Report to the Future Melbourne (Planning) Committee

**Planning Permit Application: TP-2015-906
88 Park Street South Yarra**

DELEGATED PLANNING APPLICATION REPORT

Application number:	TP-2015-906
Applicant:	George Nedovic
Address:	88 Park Street, SOUTH YARRA VIC 3141
Proposal:	Demolition of the existing dwelling and construction of a new two storey dwelling
Date of application:	7 October 2015
Responsible officer:	Oh Young Lee

Shadows 11AM 1:100

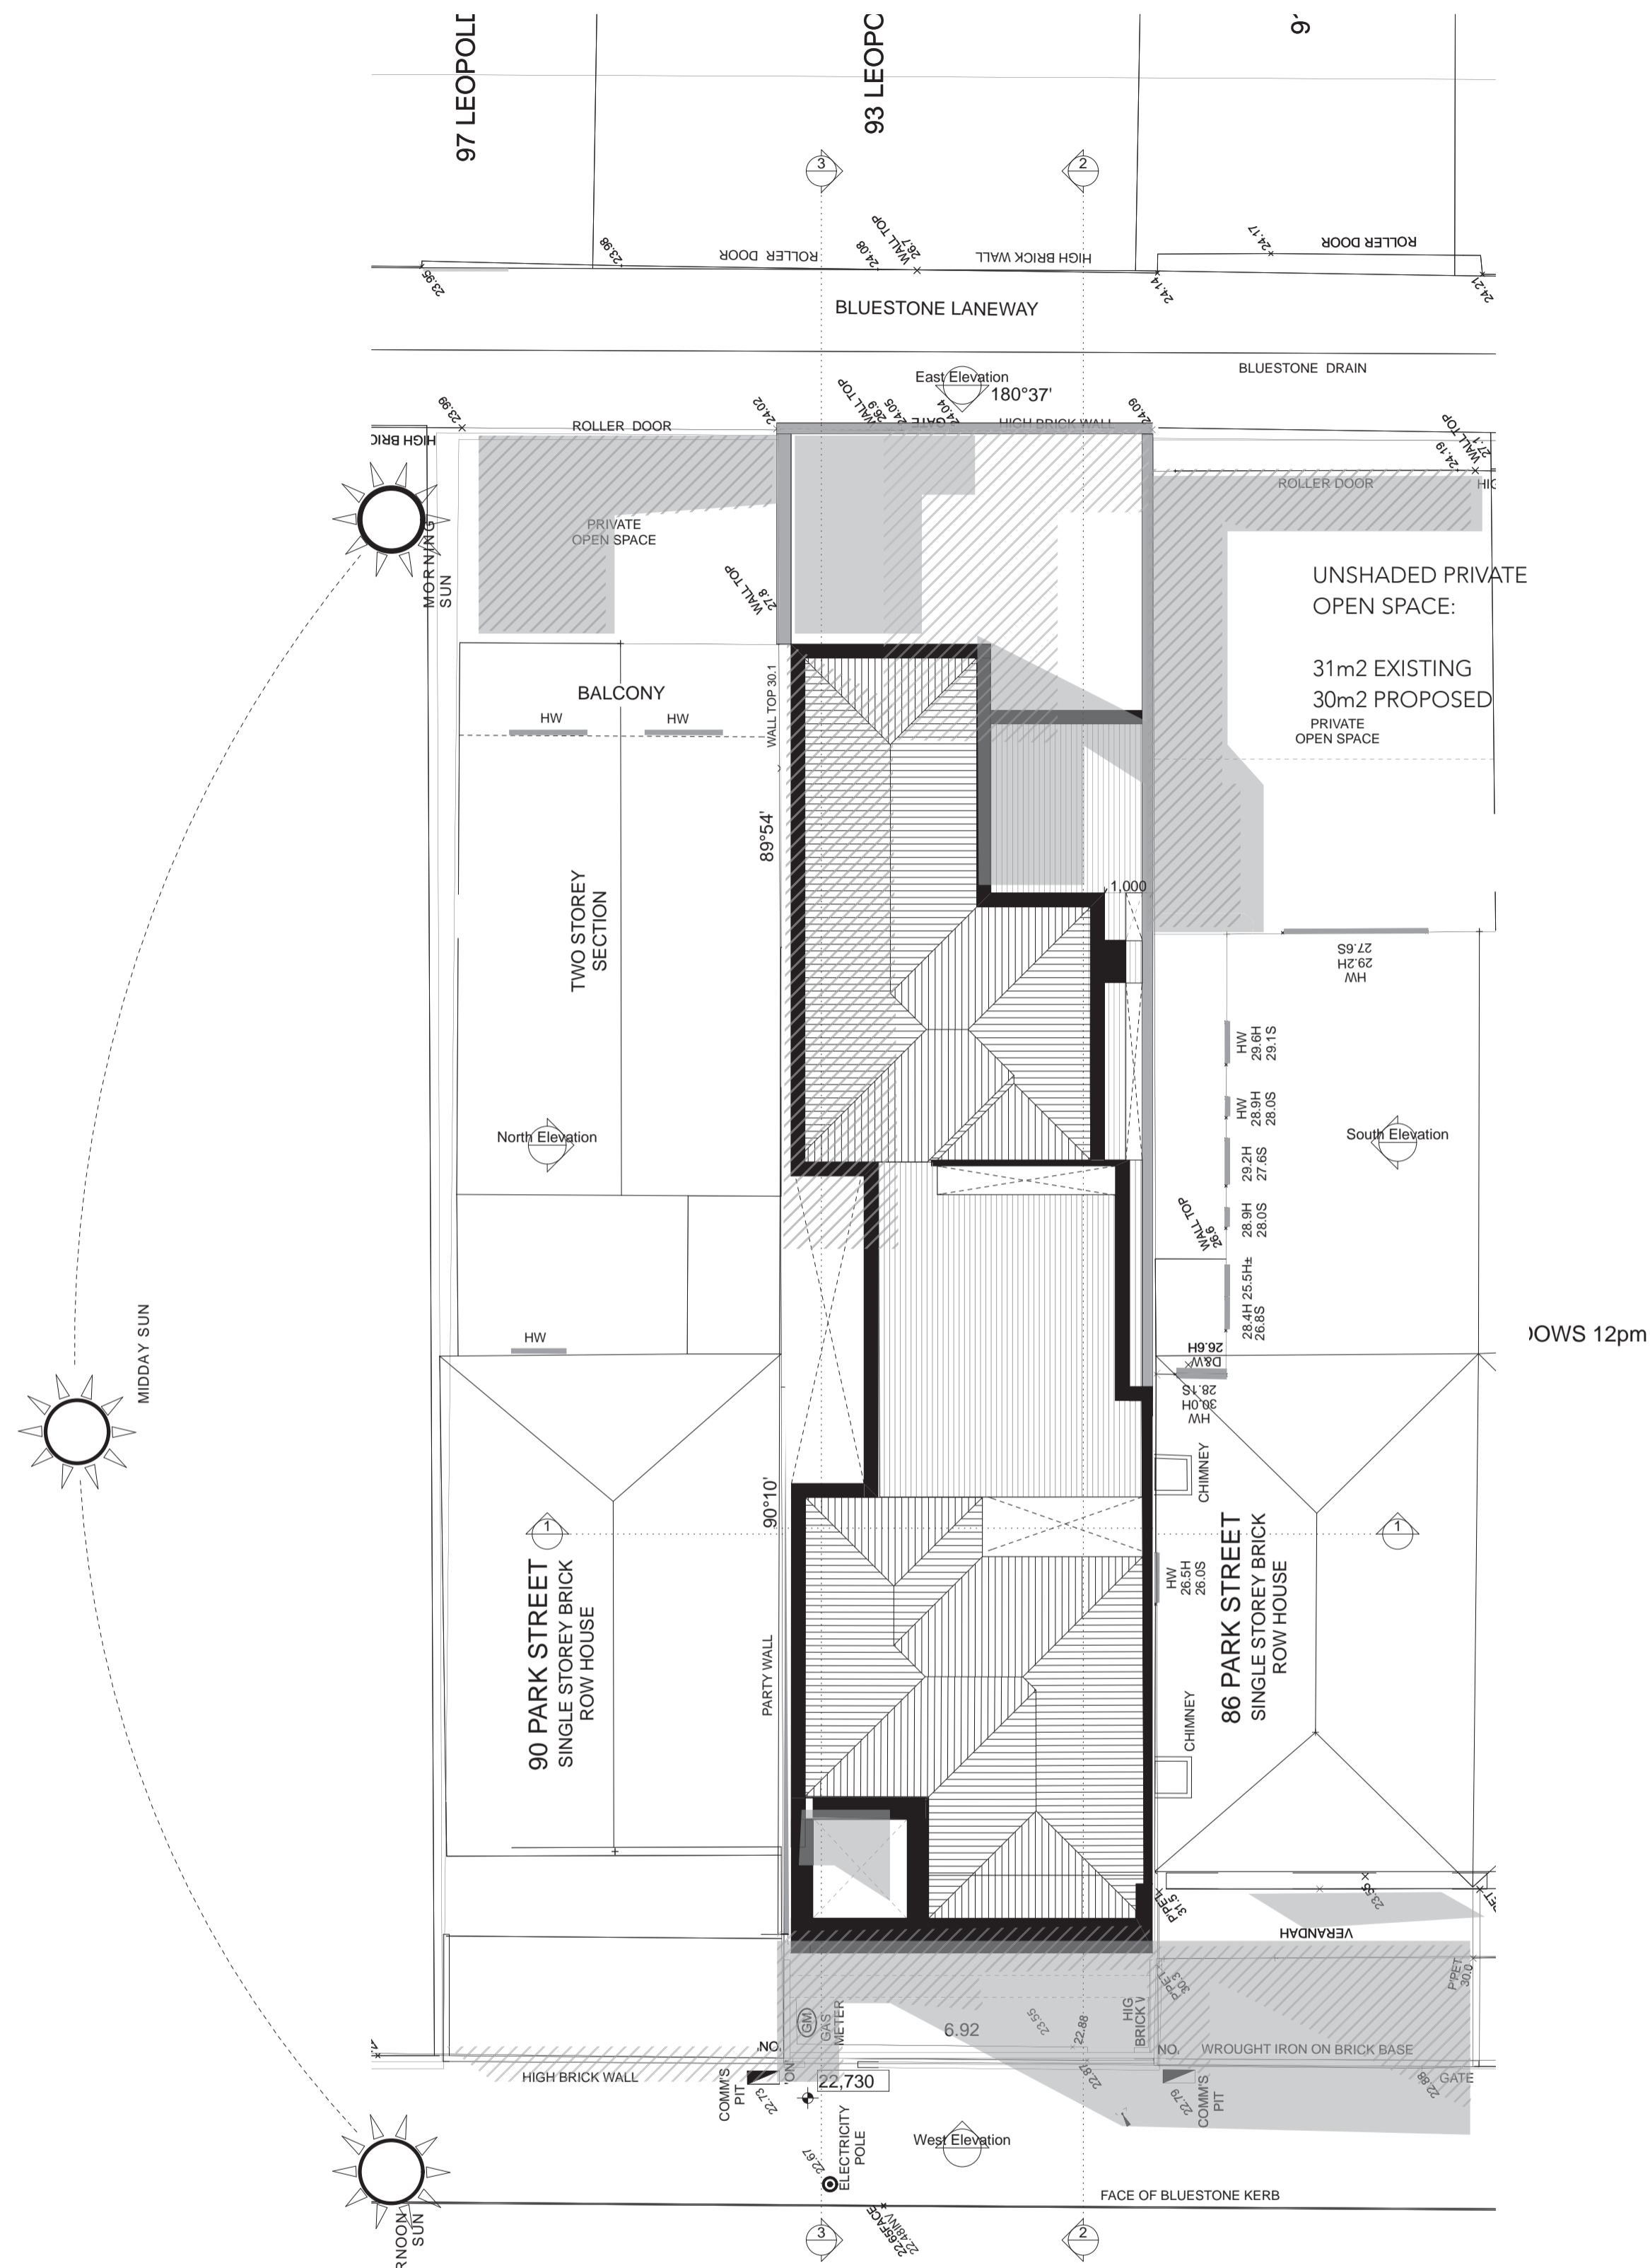
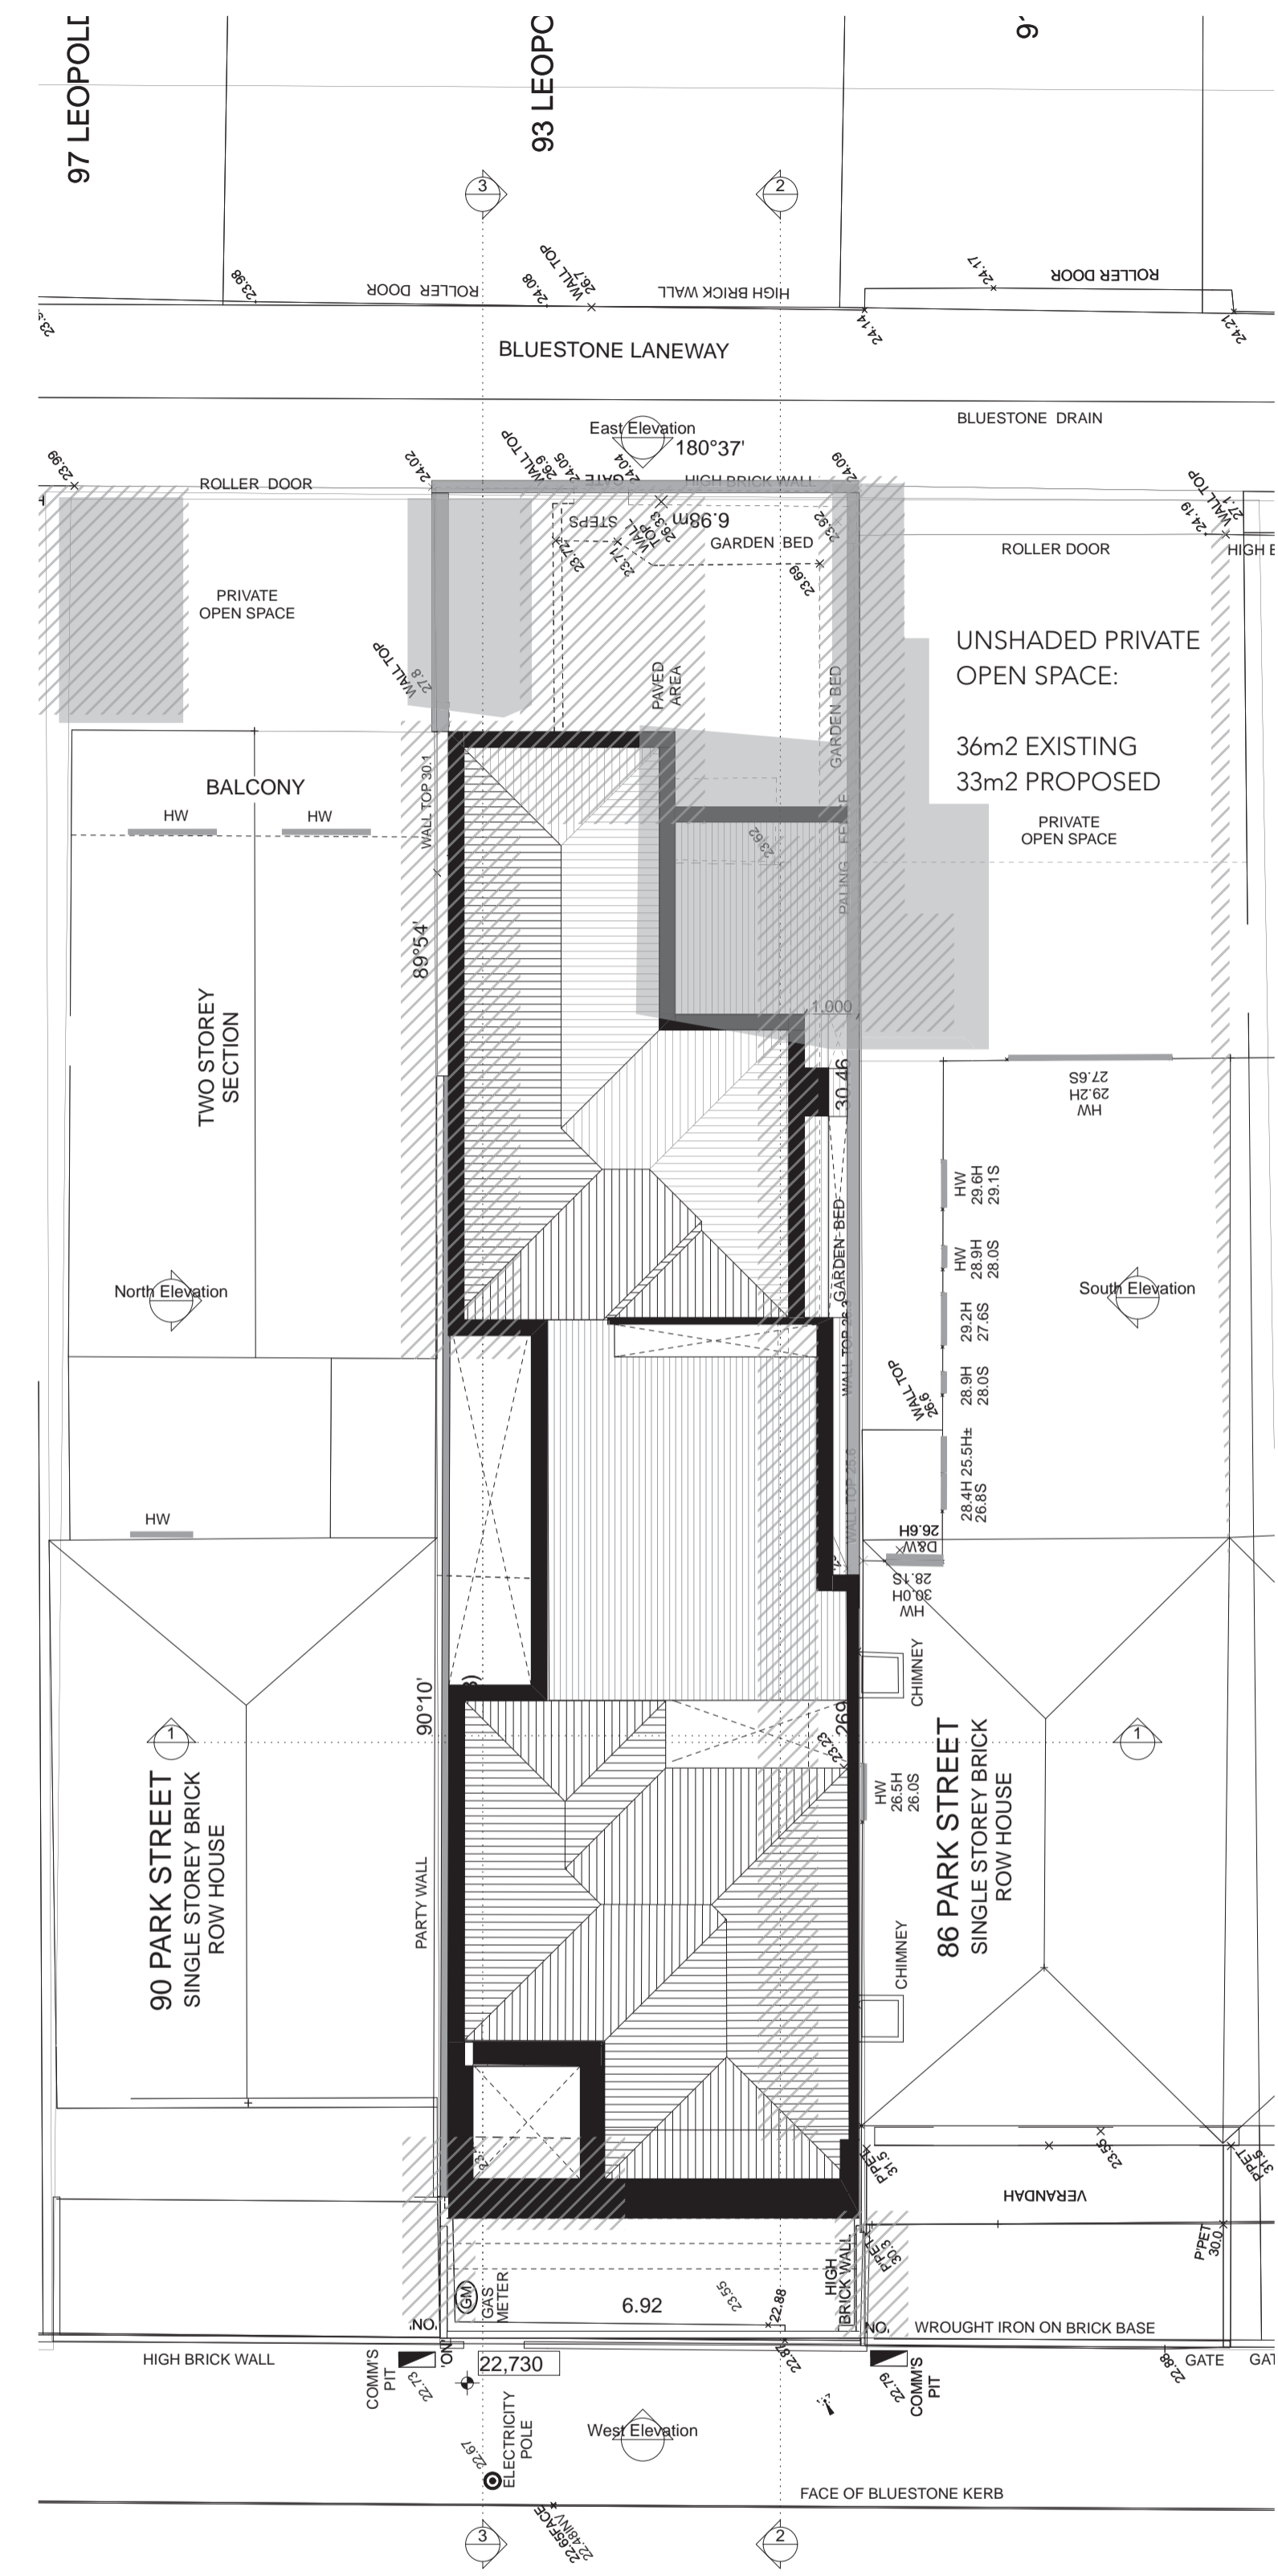
Overall it is considered that no adjoining property will be unreasonably impacted. It is also noted that the shadow diagram provided by the applicant is not reflective of the agreed setback of 1 metre to first floor bathroom and laundry, hence the impact depicted on these plans is likely to be reduced further as a result of this change.

- The existing light court and the skylight which may experience some of shadow from the proposal (although it is unclear from the shadow diagrams) are already overshadowed partially by the existing vegetation along the southern edge of the subject site.
- The applicant has agreed to a condition to provide a minimum 1 metre setback to the first floor walls located adjacent to these skylights, which would further reduce the impact.
- The objective and standard for overshadowing refers to impact on *secluded private open space*, not habitable room windows or private open space.
- It is also noted that the family room has access to daylight through full width glazing directly open to the private open space at the rear of the property and the existing skylight is not the only source of daylight to this room.
